METHOD OAKS SUBDIVISION S-57-2016

Case File / Name: S-57-16 / Method Oaks Subdivision

Development Services Design Adjustment - Staff Response

SUBJECT: S-57-16 / Method Oaks Subdivision

Method Oaks Subdivision Map

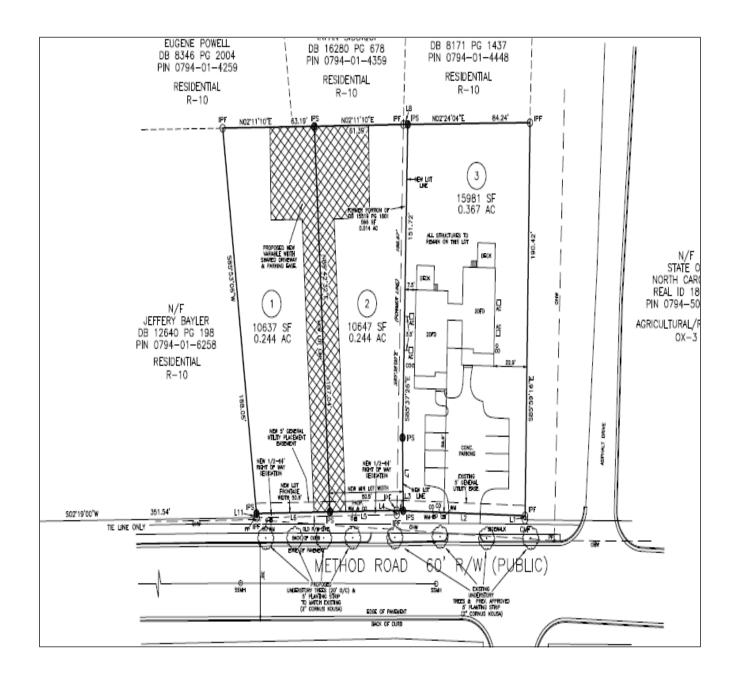
Design Adjustment: Two Design Adjustments have been approved by the Development Review

- The block perimeter requirement be waived for this site due to the constraints of a two-lot subdivision (100' frontage) that would not be able to

accommodate a public street through the site and also the restrictions of I-

440 to the west.

The street trees are being located within the planting strip between the back-

of-curb and sidewalk as was provided in the north adjacent lot.
